9.3 Bus movements from the Pioneer Avenue compound (C8)

9.4 Amended construction haulage routes

Figure 9-14 Southern interchange compound access arrangement C5-3

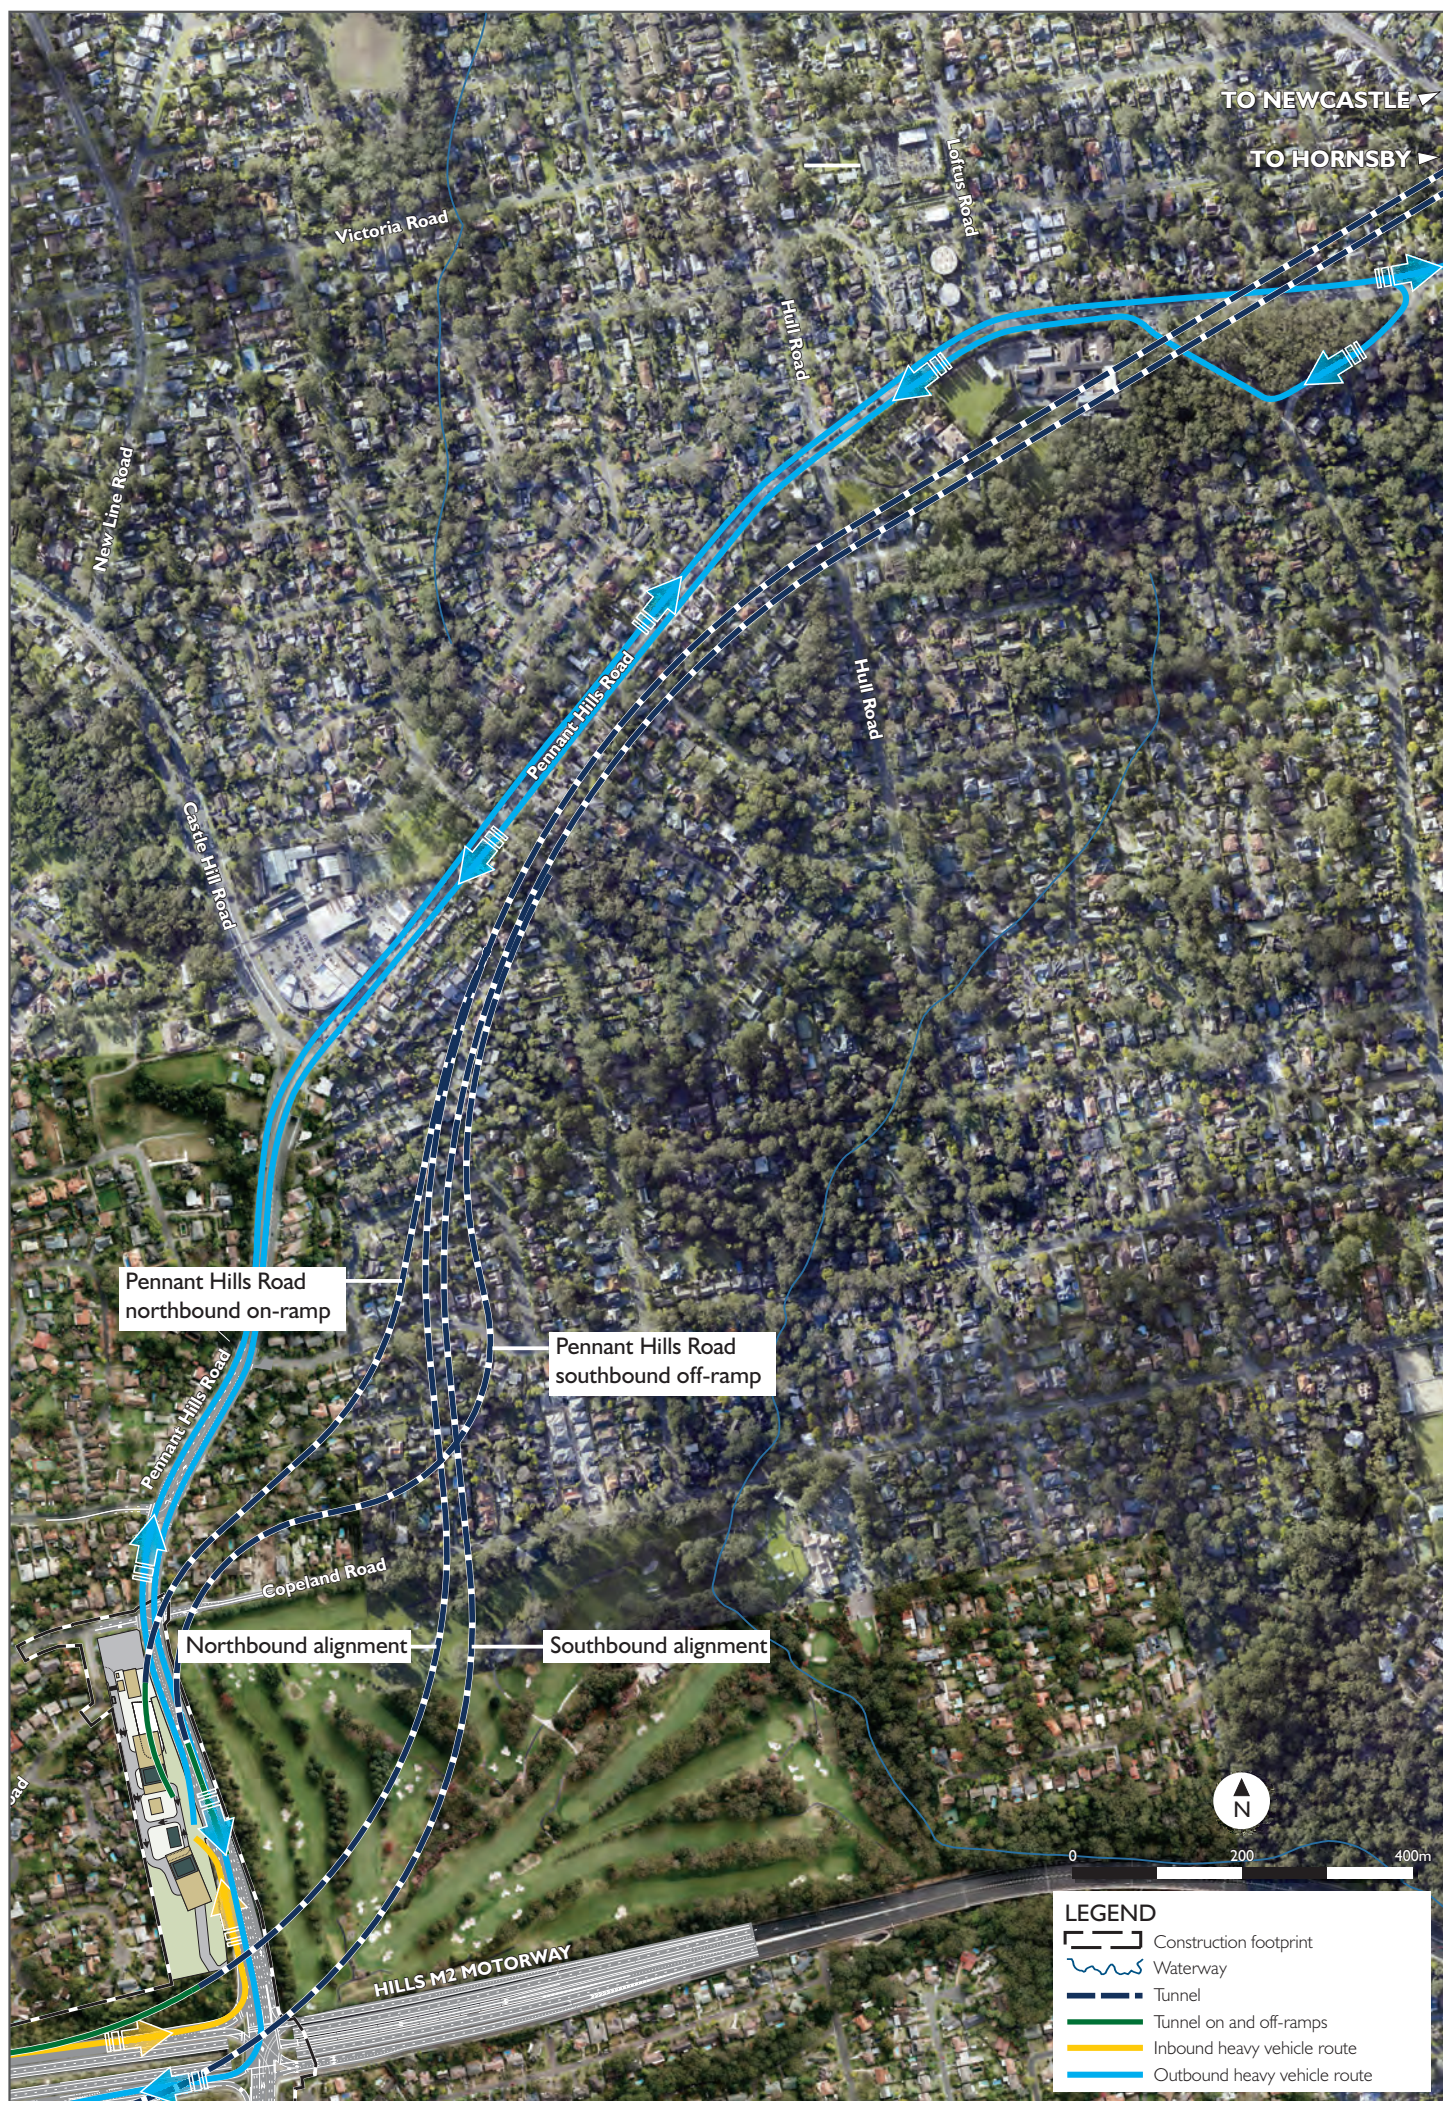
Access arrangement C5-3 involves the provision of a left in, left out access from Pennant Hills Road. Outside of peak traffic periods, heavy vehicles would be able to turn around at Beecroft Road (around Observatory Park) to travel to a southern / western spoil disposal site. This access arrangement is shown on **Figure 9-14**.
